Kirby Morgan Dive Systems, Inc.®

Bulletin #5 of 2007. June 12, 2007

Change to Product

Microphones Now Shipping With Strain Relief Ring & Equalizing Vent

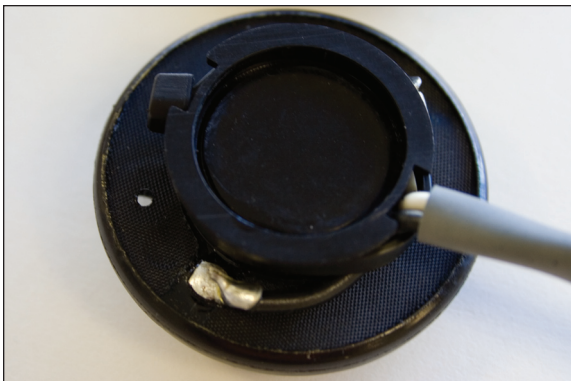
As of May 31, 2007, all microphone assemblies and spare microphones are being shipped with the following changes.

- 1) The addition of a strain relief ring attached to the back side. The strain relief is not available as a spare part.
- 2) The addition of a small equalizing vent on the back side.

The strain relief will provide needed support for the wire connection. It was found that frequent removal of the microphones from the oral nasal could cause stress to the wires where they attach and cause the solder joint to fail.

The protective membrane at the back side of the speaker, was in some cases, too slow to respond to changes in pressure. This caused the speaking diaphragm to either collapse partially or completely. This would diminish or destroy the diaphragms functioning. The addition of a small vent hole will prevent this from occurring.
